BRUNSWICK-GLYNN COUNTY JOINT WATER & SEWER COMMISSION

**PROJECT: INVITATION TO BID NO. 23-011 NORTH MAINLAND WATER
LOOPS CONSTRUCTION**

ADDENDUM: Three (3)

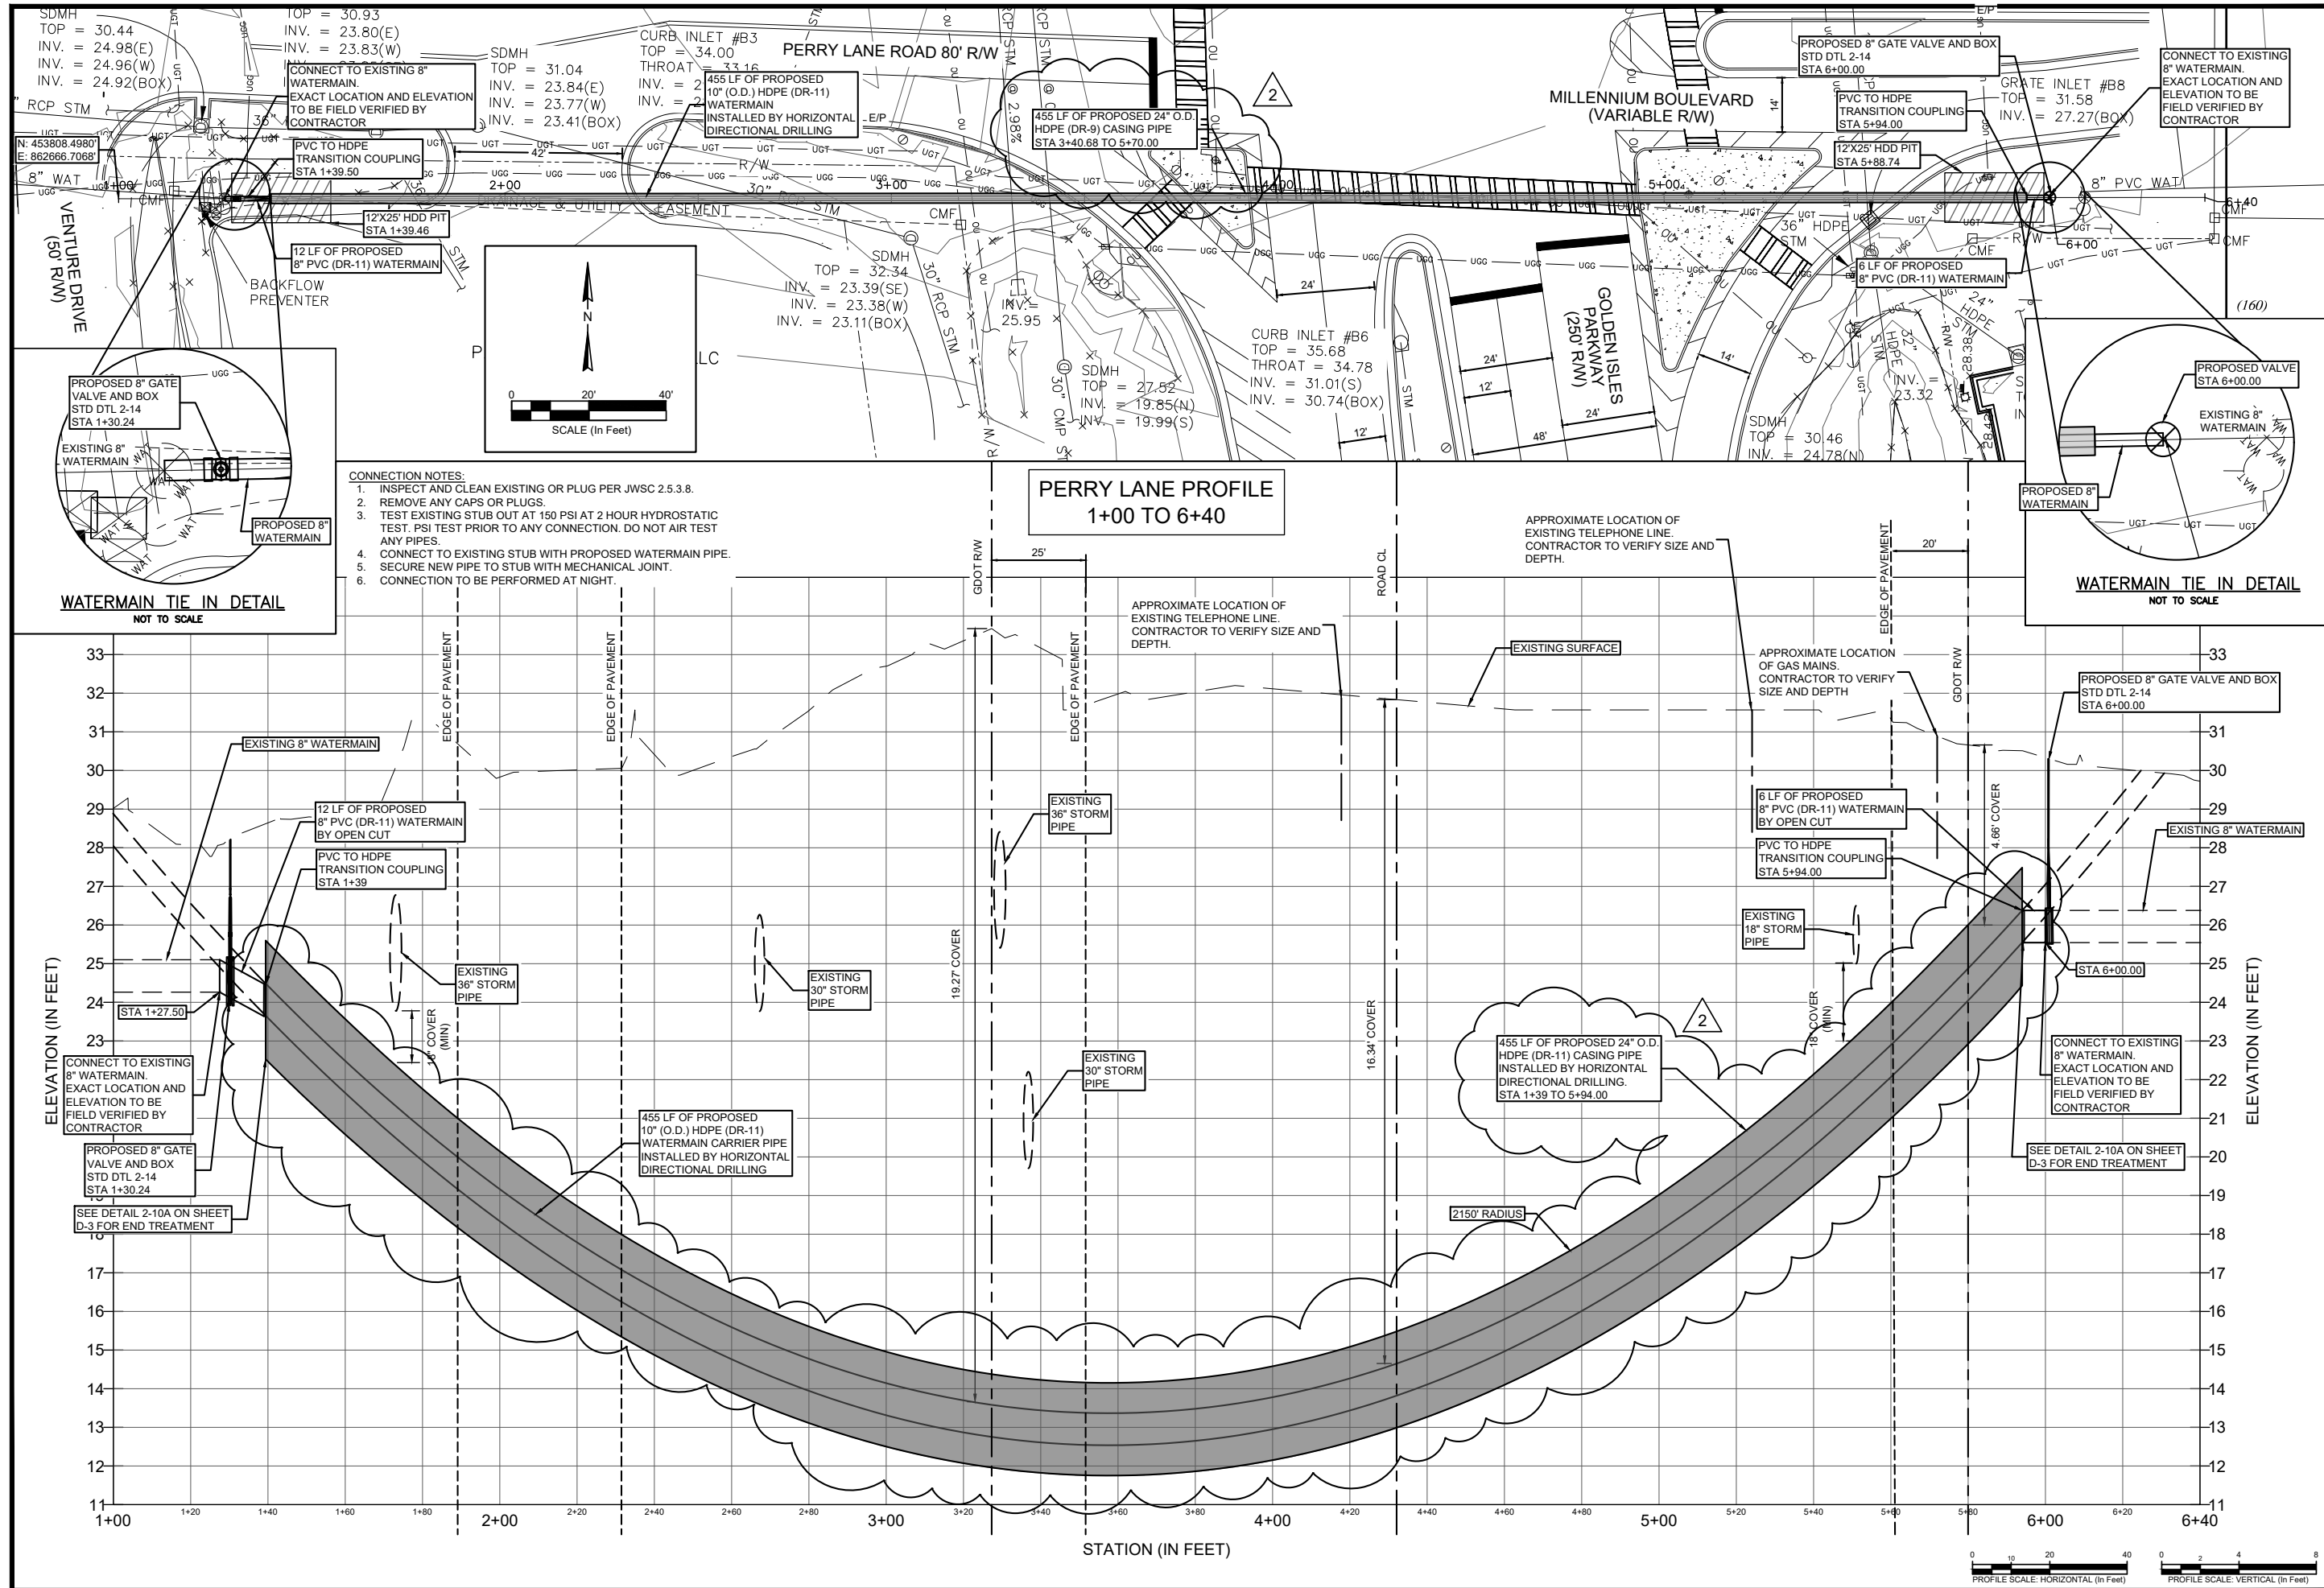
- 1) QUESTION: Bid Item #14 is for 24" OD HDPE horizontal directional drilling, but we do not see that called out on the plans. The three locations of horizontal directional drilling shown on the plans is covered by bid items 12 and 13. Please confirm that bid item 14 is an error and will be removed.**

ANSWER: The 24" OD HDPE horizontal directional drilling (bid item #14) is for a casting pipe under Golden Isles Parkway (Project Area #3), in which the 10" OD pipe will be a carrier pipe that is inserted into the larger pipe. This is described within Section 01010 "Summary of Work" on the specifications. A revised drawing will be provided to further clarify this scope of work.
